ADDENDUM NO. 2

December 9, 2022

BAILLY ELEMENTARY SCHOOL ADDITIONS AND RENOVATIONS Chesterton, IN 46304

Addendum Two (AD.02) to the drawings and specifications prepared by Gibraltar Design for **Bailly Elementary School Renovations** for Duneland School Corporation, Chesterton, Indiana.

UNIT "C" FIRST FLOOR
REFLECTED CEILING PLAN

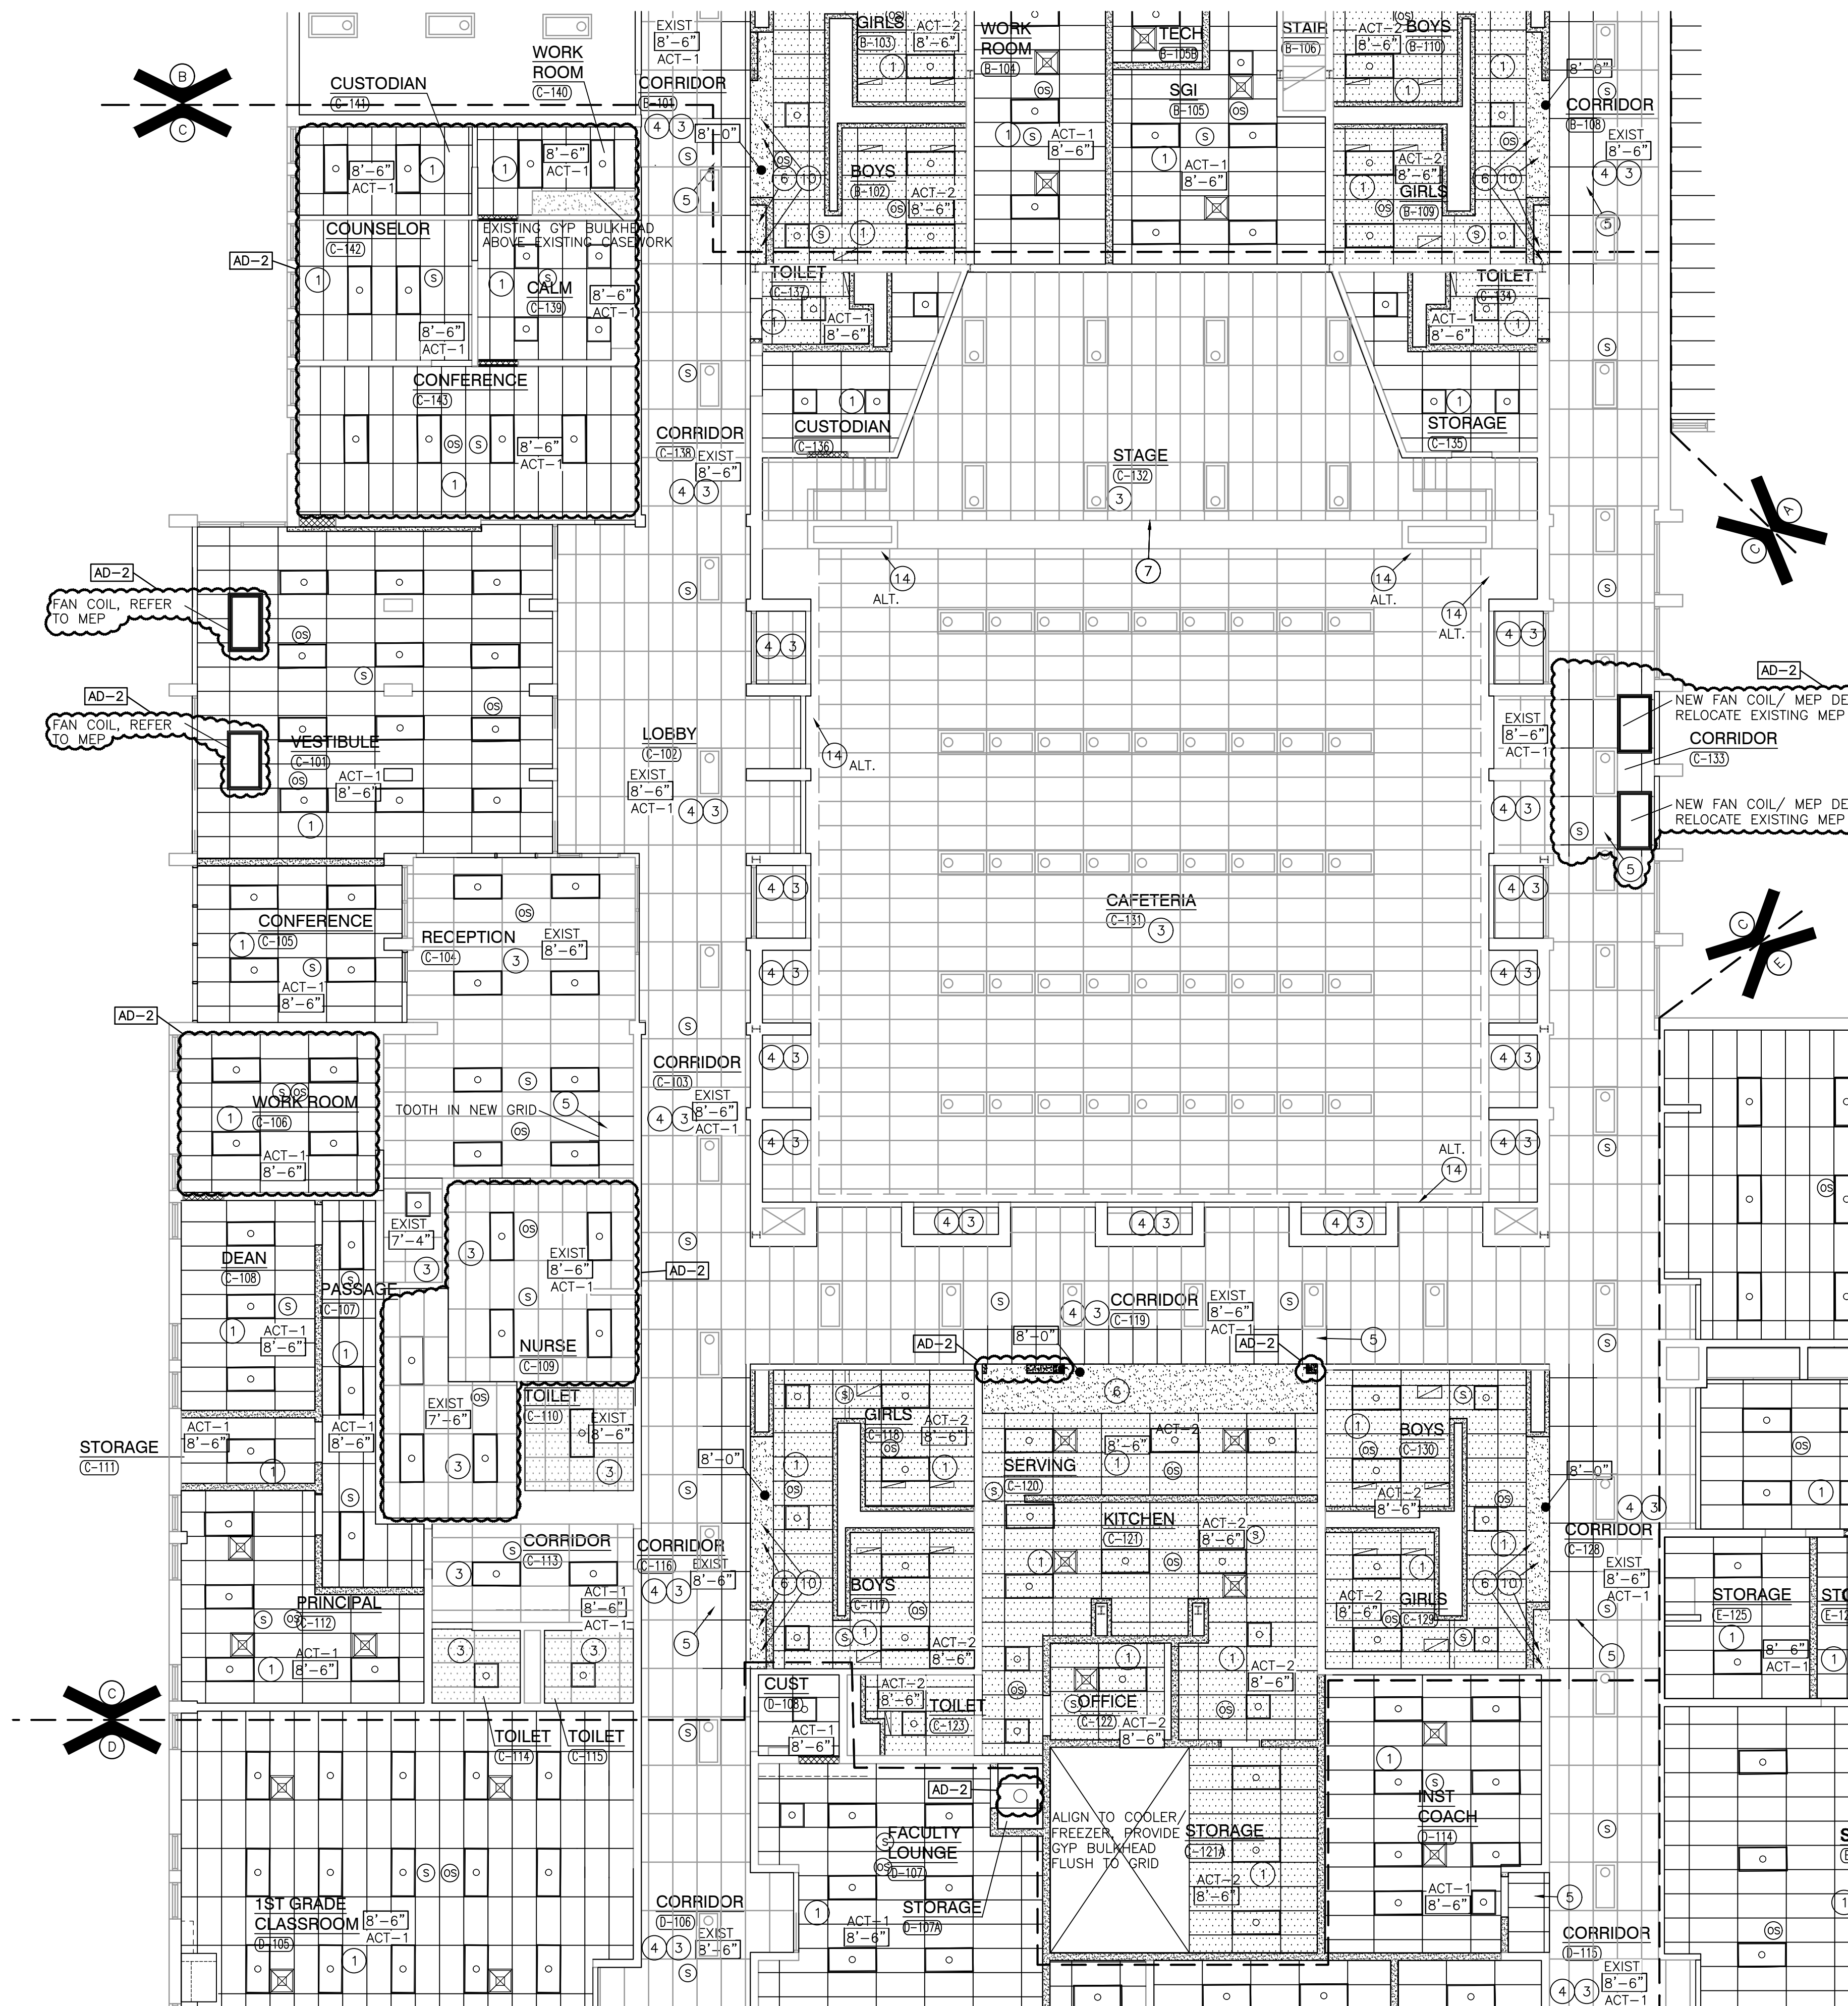
- A. Refer to revised full size drawing included in this addendum for the following revisions:
1. Update ceiling orientation in the following rooms: Nurse C-109, Calm C-139, Work Room C-140, Custodian C-141, Counselor C-142, Conference C-143.
 2. Update to indicate ceiling grid and pad modification and ceiling mounted cabinet heaters in Corridor C-133, and Vestibule C-101.
 3. Update to indicate new acoustical ceiling grid, pads and suspension system in the following rooms: Custodian C-141, Work Room C-140, Counselor C-142, Calm C-139, Conference C-143, Work Room C-106.

UNIT "D" FIRST FLOOR
REFLECTED CEILING PLAN

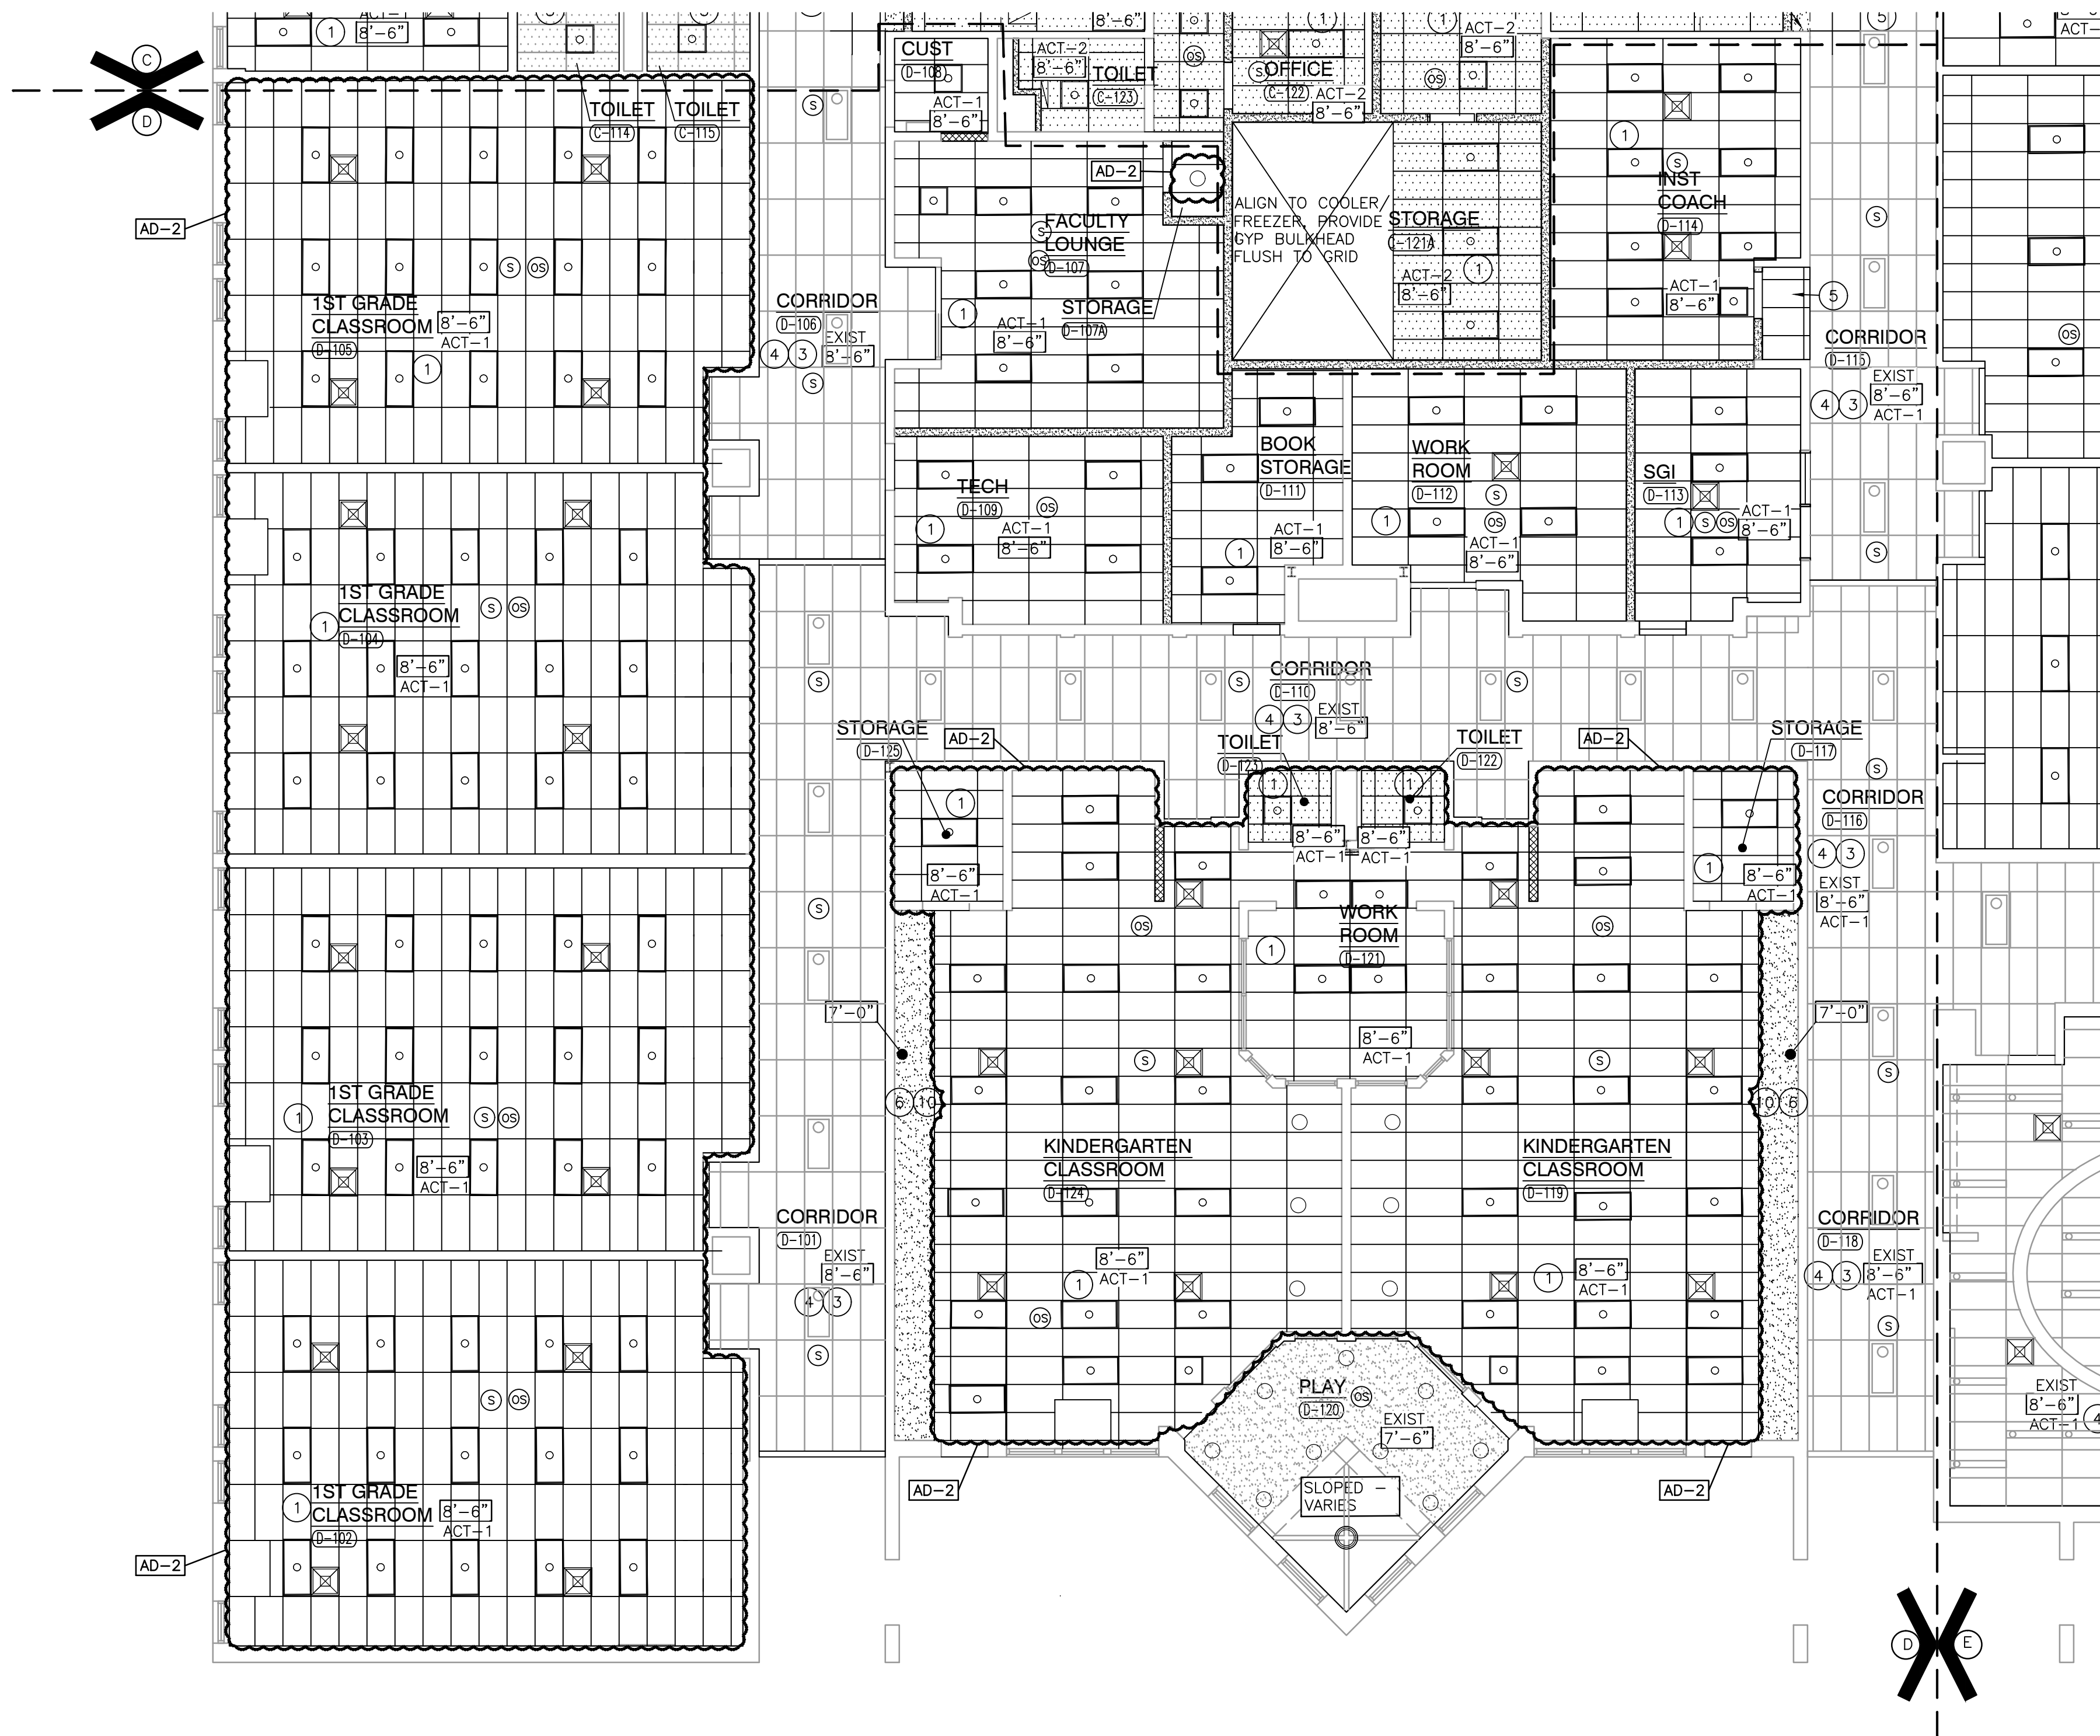
- A. Refer to revised full size drawing included in this addendum for the following revisions:
1. Update ceiling orientation in the following rooms: 1st Grade Classrooms D-102, D-103, D-104, and D-105.
 2. Update to include light in Storage D-107A.
 3. Update to indicate new acoustical ceiling grid, pads and suspension system in the following rooms: 1st Grade D-105, 1st Grade D-104, 1st Grade D-103, 1st Grade D-102, Kindergarten Classroom D-124, Kindergarten Classroom D-119, Storage D-125, Storage D-117, Toilet D-123, Toilet D-122.
